Project	IEEE 802.16 Broadband Wireless Access Working Group < http://ieee802.org/16 >	
Title	Corrections for the MS's Authorization Flow	
Data Submitted	2005-05-05	
Source(s)	Seokheon Cho Sungcheol Chang Chulsik Yoon, ETRI 161, Gajeong-dong, Yuseong-Gu, Daejeon, 305-350, Korea Yigal Eliaspur Intel Corp.	Voice: +82-42-860-5524 Fax: +82-42-861-1966 chosh@etri.re.kr
Re:	IEEE P802.16e/D7	
Abstract	The existing PKMv2 is somewhat unorganized and insecure security framework. This contribution provides a resolution for unorganized and insecure MS's authorization flow in the PKMv2.	
Purpose	Adoption of proposed changes into P802.16e/D7	
Notice	This document has been prepared to assist IEEE 802.16. It is offered as a basis for discussion and is not binding on the contributing individual(s) or organization(s). The material in this document is subject to change in form and content after further study. The contributor(s) reserve(s) the right to add, amend or withdraw material contained herein.

Corrections for the MS's Authorization Flow

Proposed Changes into IEEE P802.16e/D7

0.1 IEEE P802.16e/D7 Status

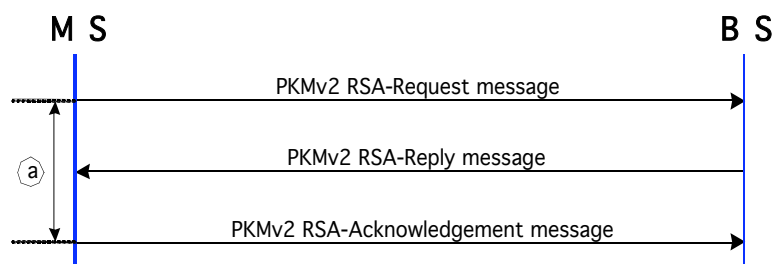
0.2 Problems

- For the RSA-based Authorization procedure:
 - The Authorization Request message and the Authorization Reply message in the RSA-based Authorization procedure are in the same rank as the EAP Transfer message in the EAP-based Authorization procedure. The Authorization Request/Reply messages contain Security-Capabilities, SAID, and SA-Descriptors, but the EAP Transfer message doesn't contain those parameters.

- The sequence number and lifetime included in the RSA-based Authorization procedure are not an AK sequence number and AK lifetime.
 - When the RSA-based Authorization procedure is selected, there is no message for informing the MS's authentication failure from BS to MS and the BS's authentication result (such as success or reject) from MS.

- For the EAP-based Authorization procedure:
 - The Key Sequence Number used in the Authenticated EAP-Transfer message is not an AK Sequence Number.
 - The BS doesn't know the completion time of the EAP-based Authorization procedure in case that EAP protocol doesn't yield AAA-key and whether an MS receives the last EAP Transfer message (such as "EAP Success" used in EAP-TLS) or not. Both the BS and the MS cannot simultaneously share the AK derived from PMK, when an MS doesn't receive the last EAP Transfer message.

0.3 Solutions

- a) For the RSA-based Authorization procedure:
 - Since the RSA-based Authorization is the same rank as the EAP-based Authorization, several attributes (such as Security-Capabilities, SAID, and SA-Descriptors) which are present in the EAP-based Authorization procedure, are omitted in the RSA-based Authorization procedure. The RSA-based Authorization procedure still supports mutual authentication. The messages in the RSA-based Authorization procedure are as follows:

- The sequence number and lifetime included in the RSA-based Authorization procedure is not an AK sequence number and AK lifetime but the PAK sequence number and PAK lifetime.

- To inform the MS's authentication failure from BS to MS, the PKMv2 RSA-Reject message is added. Also, to inform the BS's authentication result (such as success or reject) from MS to BS, Auth Result Code and Error-Code attributes shall be included in the PKMv2 RSA-Acknowledgement message.

- i. PKMv2 RSA-Request message: MS_Random, MS_Certificate

- ii. PKMv2 RSA-Reply message: MS_Random, BS_Random, Encrypted pre-PAK, Key lifetime (PAK), Key Sequence Number (PAK), BS_Certificate, SigBS
- iii. PKMv2 RSA-Reject message: MS_Random, BS_Random, Error-Code, Display-String, SigBS
- iv. PKMv2 RSA-Acknowledgement message: BS_Random, Auth Result Code, Error-Code, Display-String, SigMS
